Planning Decisions Committee

6.30pm, Wednesday 30 June 2021

Attachment 2 - PLN18/0328.02 - 459 - 471 Church Street and 20 - 26 Brighton Street Richmond - Decision Plans (1)

Attachment 7 - 46-52 Smith Street, Collingwood - Internal UD comments

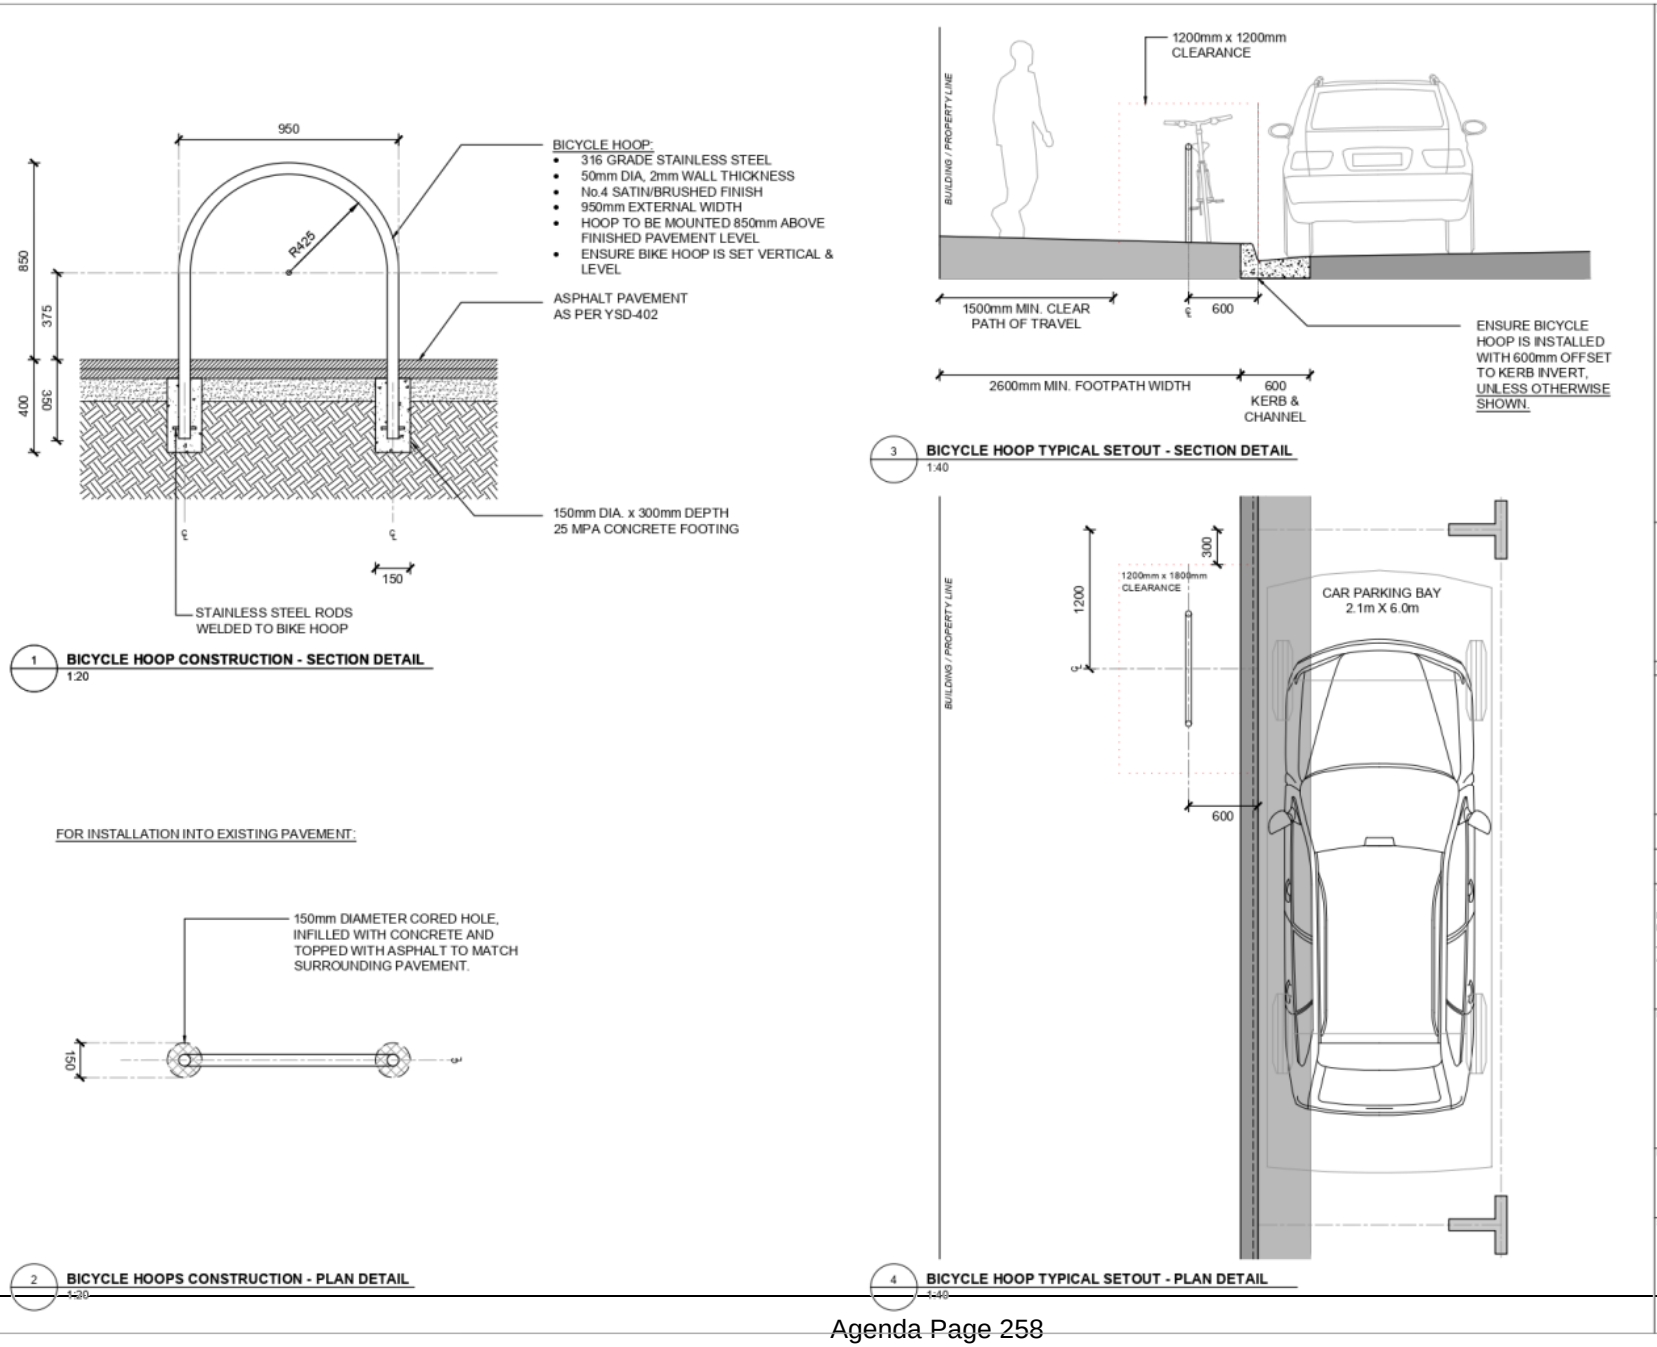
- The tree shown on the plans as proposed in the footpath by the corner on Derby Street and Smith Street, will not be required in lieu of the anticipated replacement of a removed street tree as per aforementioned comments.
- Tree protection plan must be submitted to Council for review.
- Note that trees managed by the Council must be protected during any construction activities in accordance with the Australian Standard for the Protection of Trees on Development Sites (AS 4970-2009).
